MONITORING YEAR 3 ANNUAL REPORT

KEY MILL MITIGATION SITE

RE: Final MY3 Report Review
Key Mill Mitigation Site, Surry County
Yadkin River Basin – HUC 03040101
DMS Project ID No. 100025 / DEQ Contract #7180

Wildlands Engineering, Inc. (Wildlands) has reviewed the Division of Mitigation Services (DMS) comments from the Draft MY3 Monitoring Report for the Key Mill Mitigation Site. The report has been updated accordingly. The Final MY3 Monitoring Report and the digital are included. Wildlands' responses to DMS' report comments are noted below in *italics*.

Figure 1a. Current Condition Plan View Map
 Key Mill Mitigation Site
 DMS Project No. 100025
 Monitoring Year 3 - 2022
 Surry County, NC

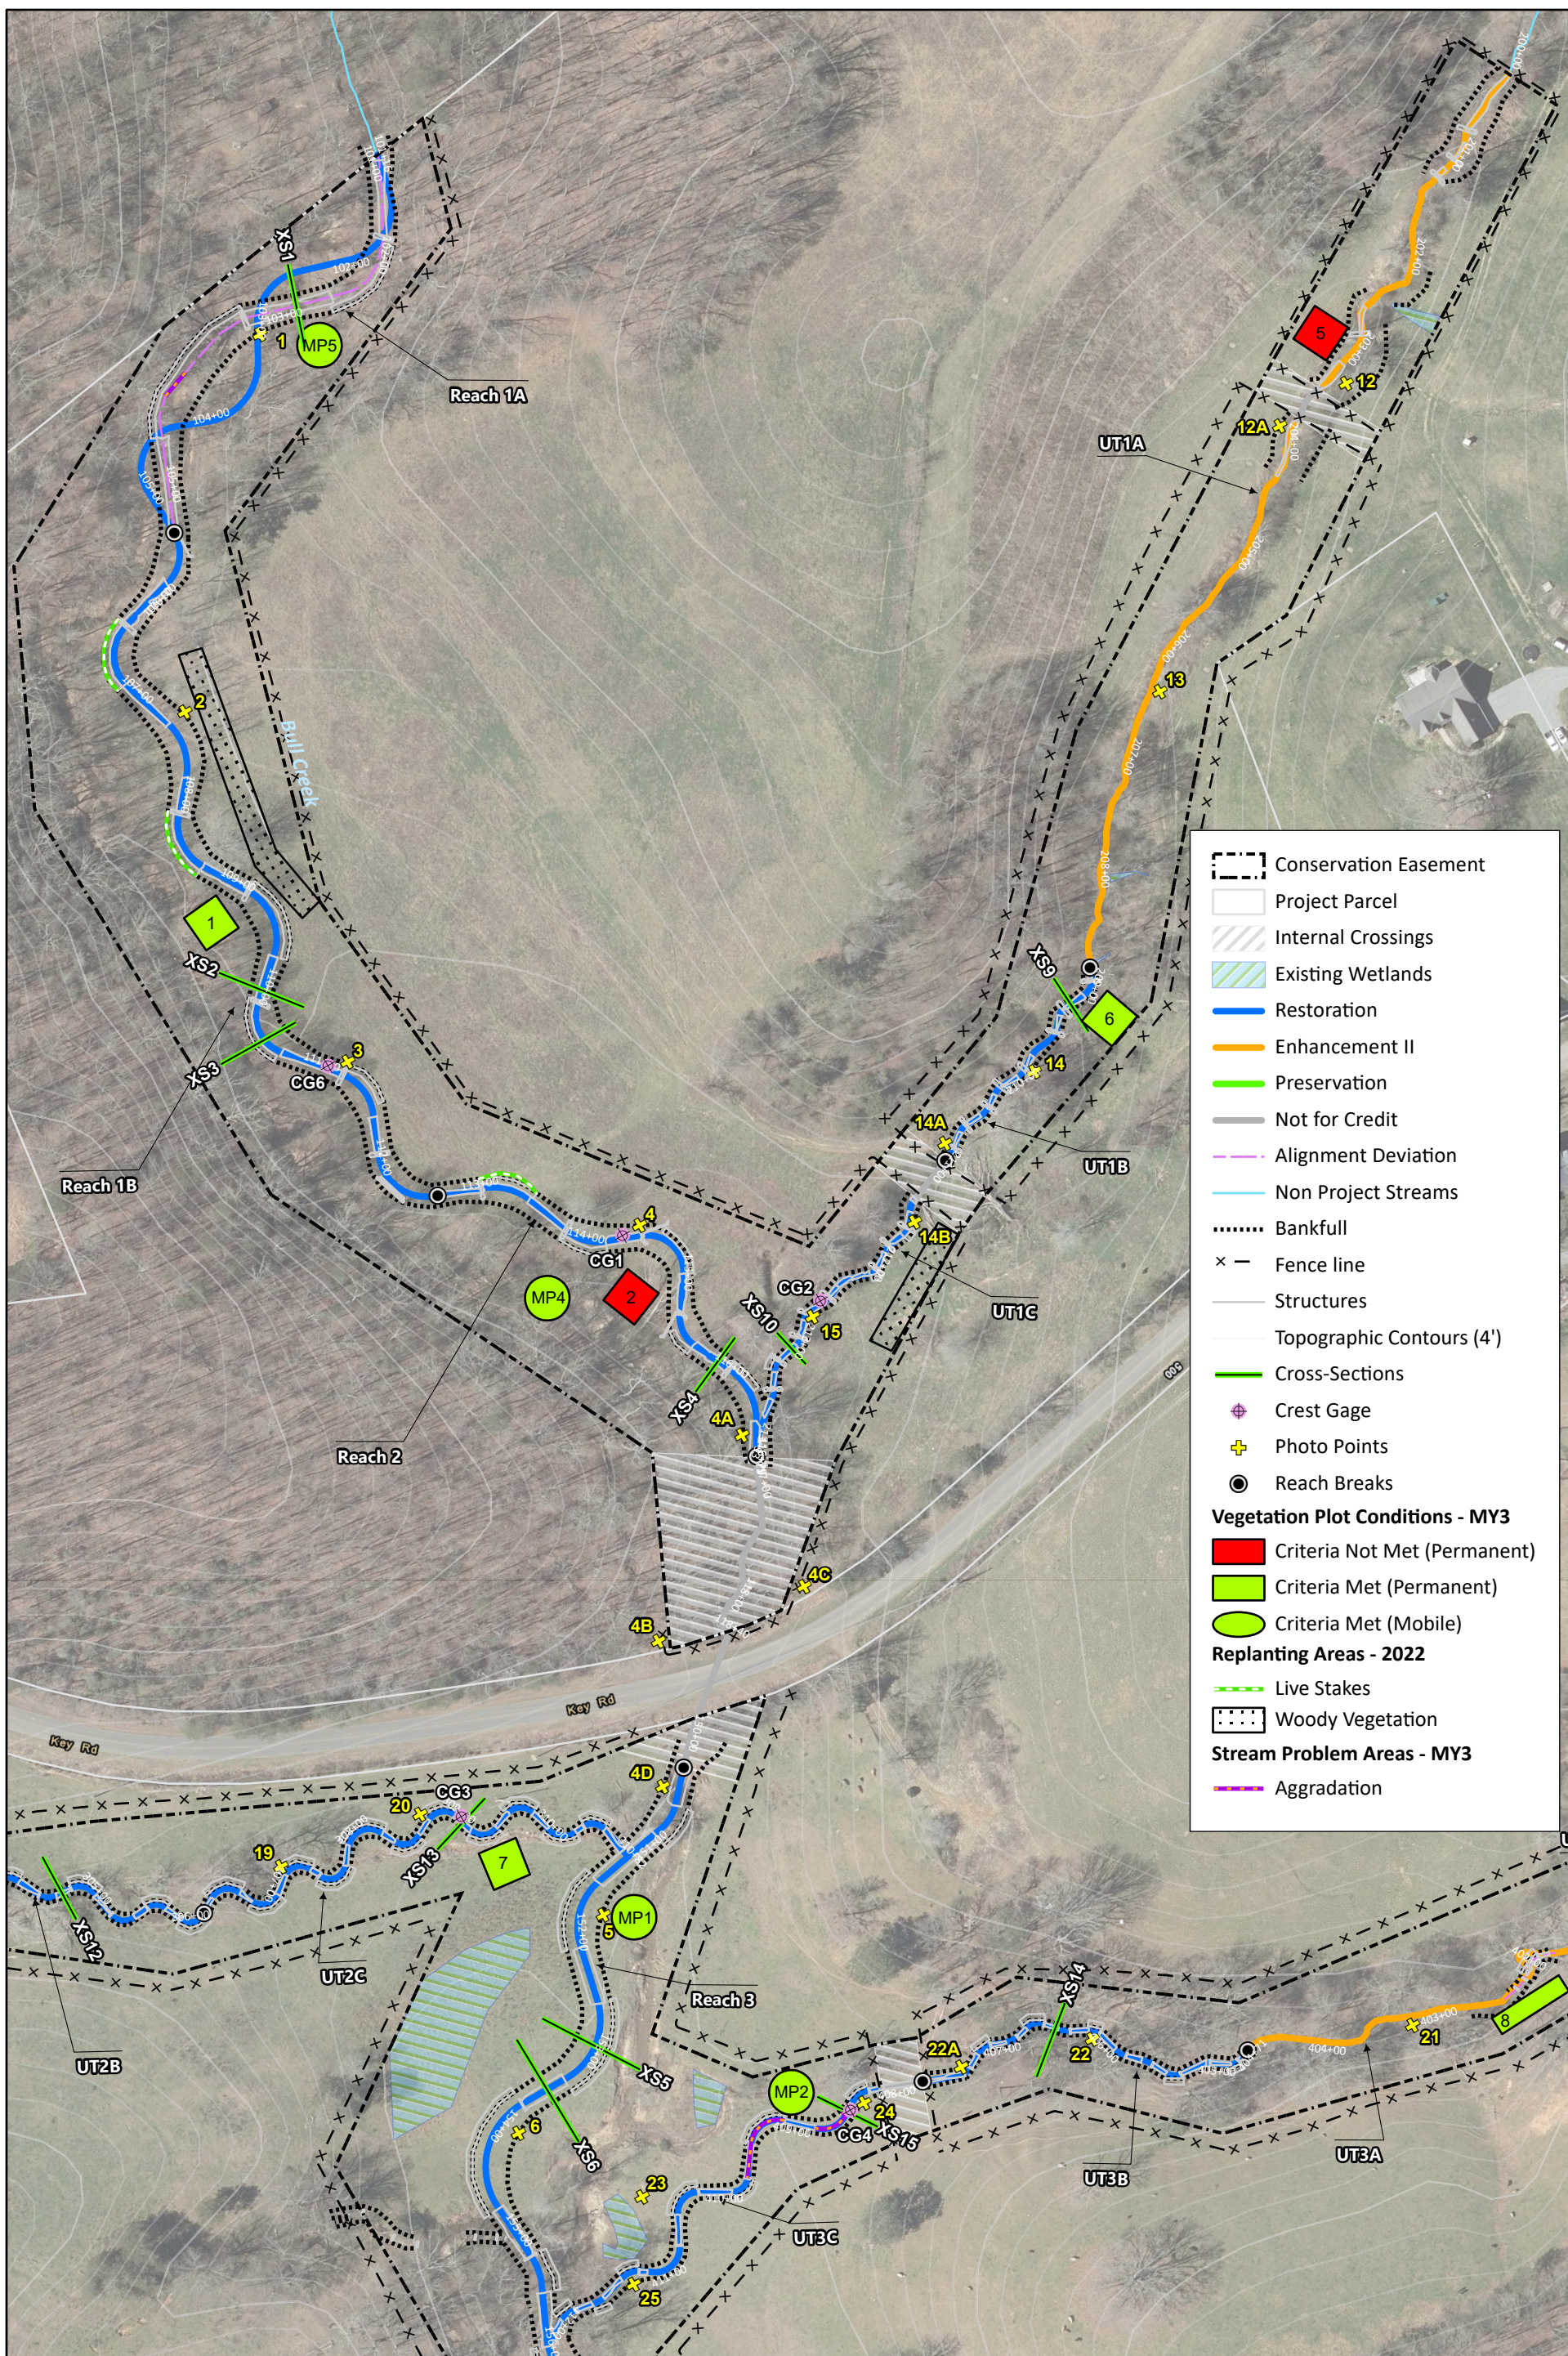
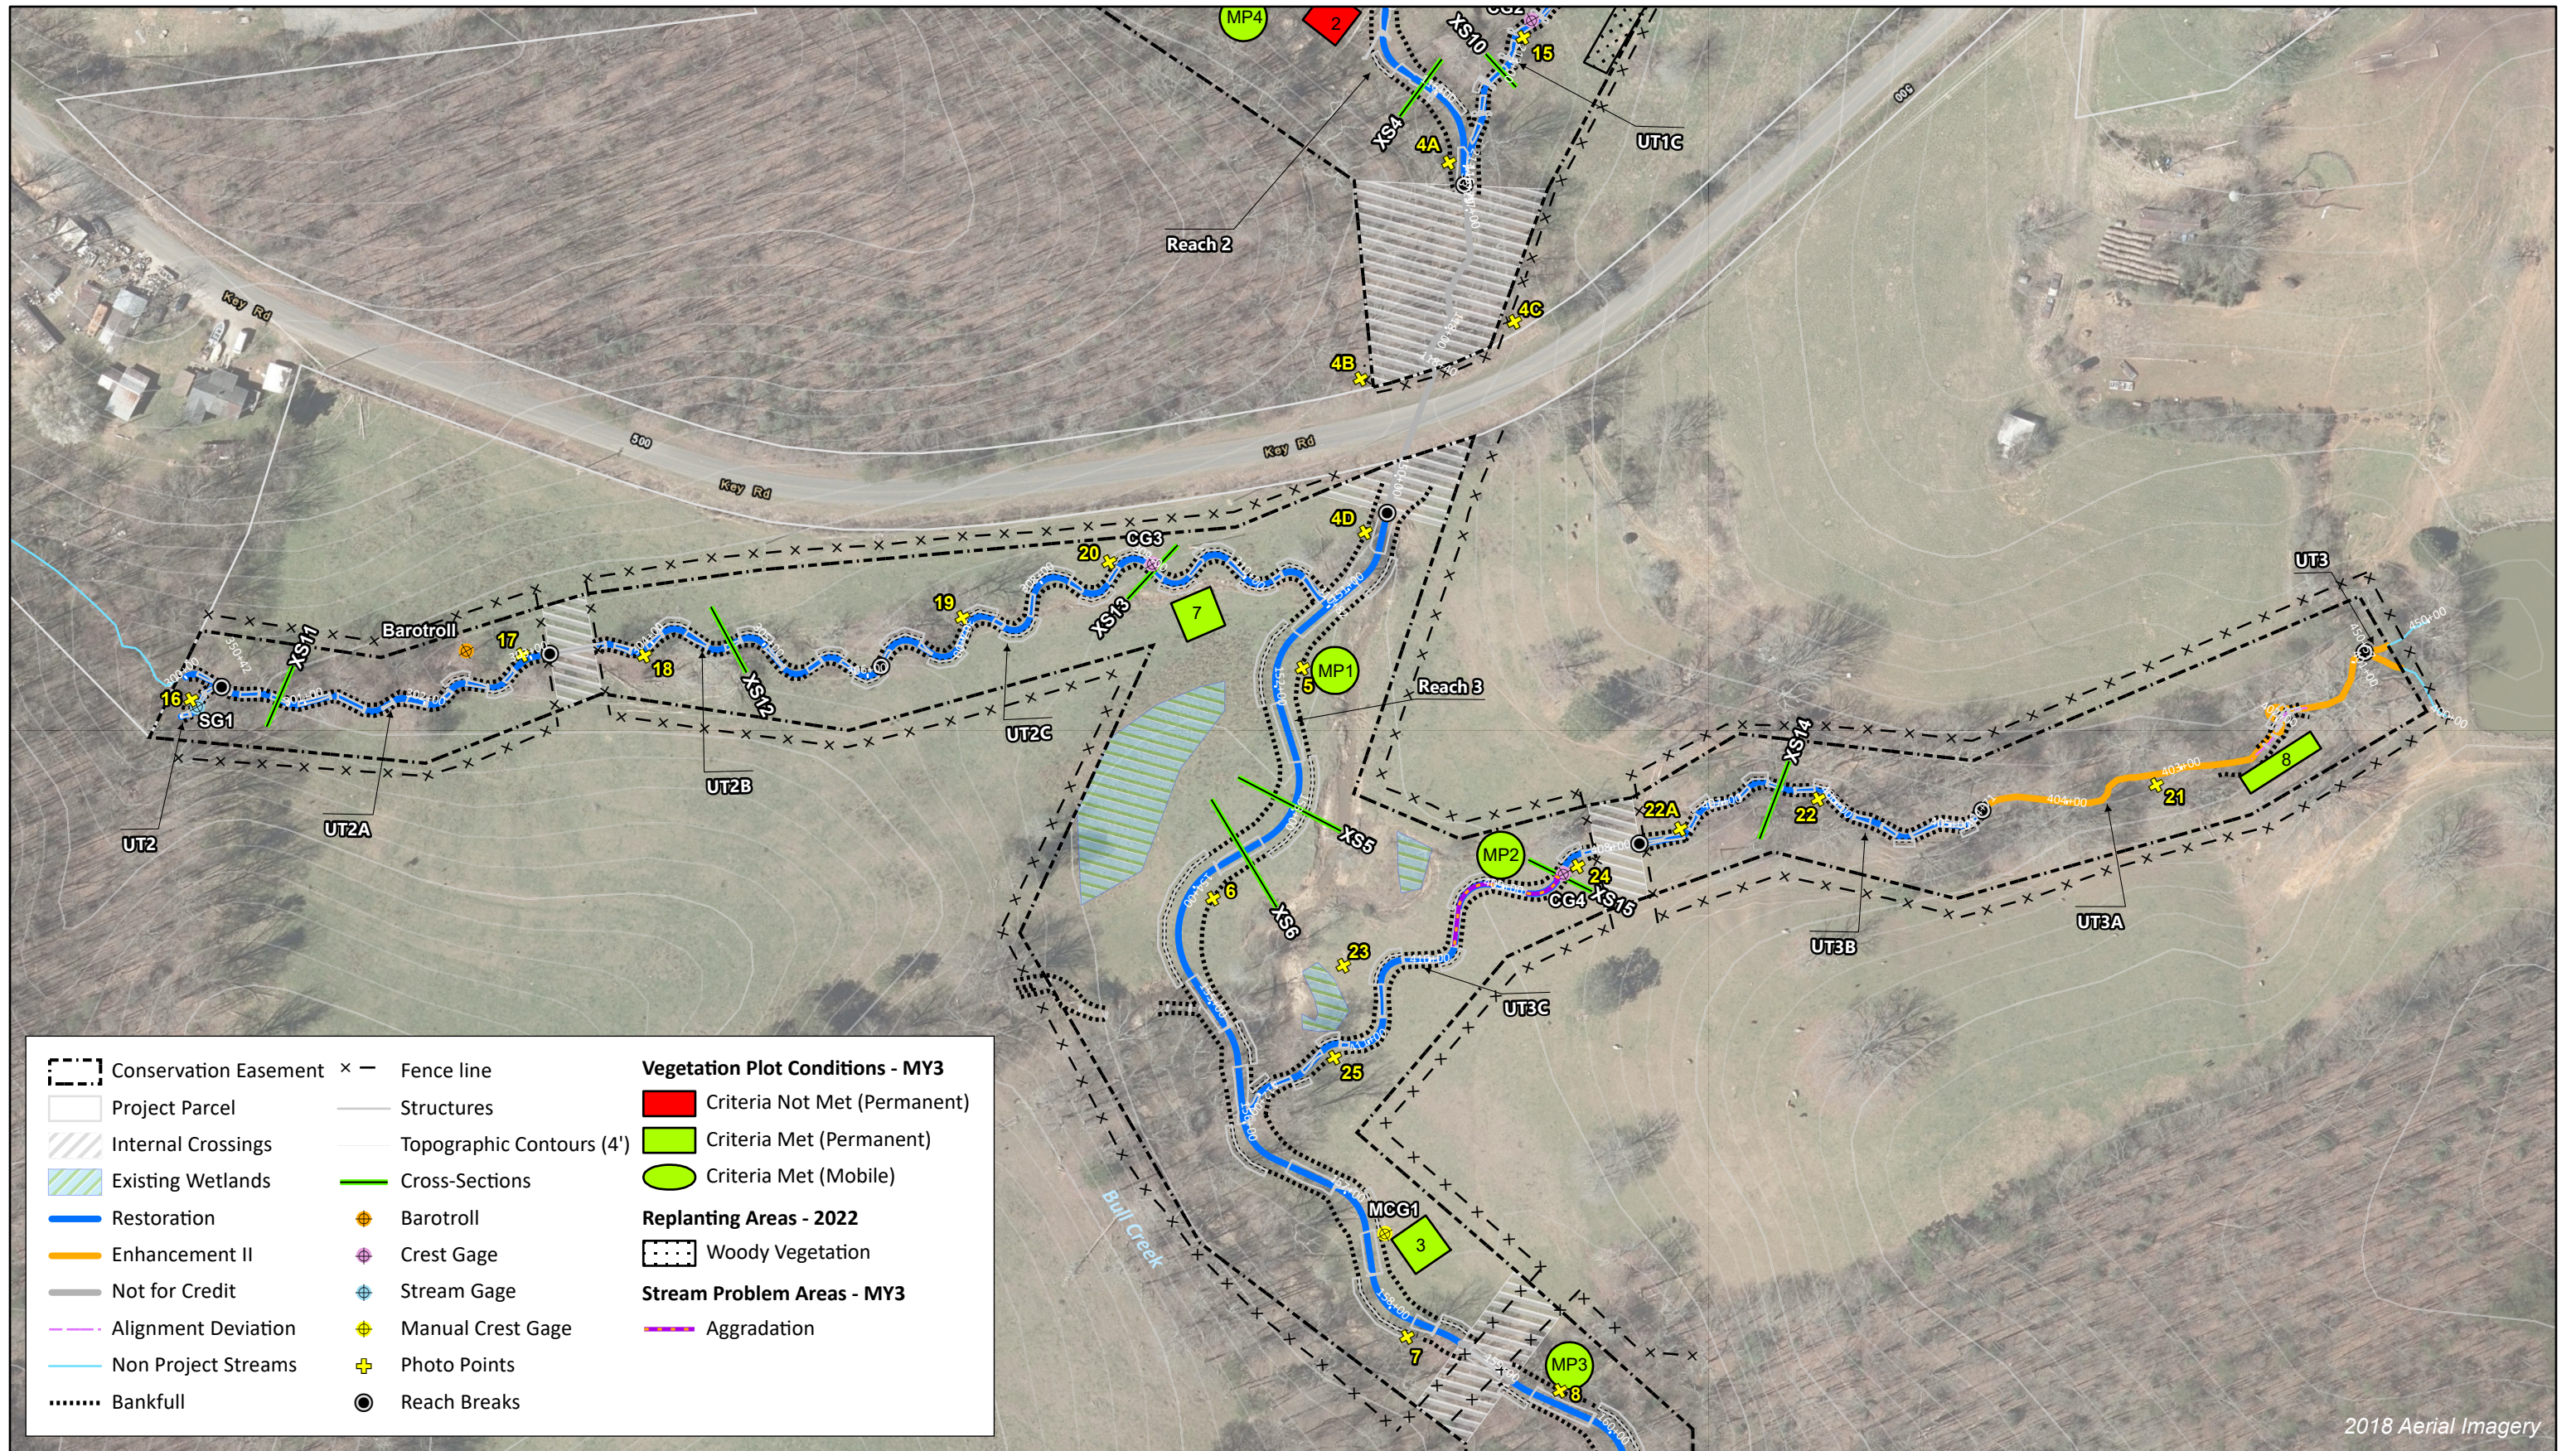
DMS comment: CCPV: Figure shows the fence line within the conservation easement in numerous locations. Please verify no fence is installed within the conservation easement and revise layer, as necessary.

DMS comment: CCPV: Please include the piping structures on Bull Creek R3 on CCPV. Currently, an area of erosion is shown in the general location.

Wildlands' response: Wildlands verified that no fencing has been installed within the conservation easement (CE). The issue is with the GIS symbol used to reflect the placement of the fence. The symbol has been corrected and updated, and it now correctly reflects that the alignment of the fence is not within the CE boundary.

Wildlands' response: The CCPV figures depicted the issue on Bull Creek Reach 3 as scour within the riffle since the piping and the displacement of each log is part of a single riffle structure; however, after a brief discussion with DMS, it was decided to document the issue as part of a single engineered structure. Therefore, the symbol within the CCPV figure has been changed to depict it as a structure issue and recorded on Table 4d. under the channel sub-category as a piping and overall integrity issue, rather than a bed stability degradational issue. Both Table 4d and Figures 1a – 1c have been updated to reflect this change.
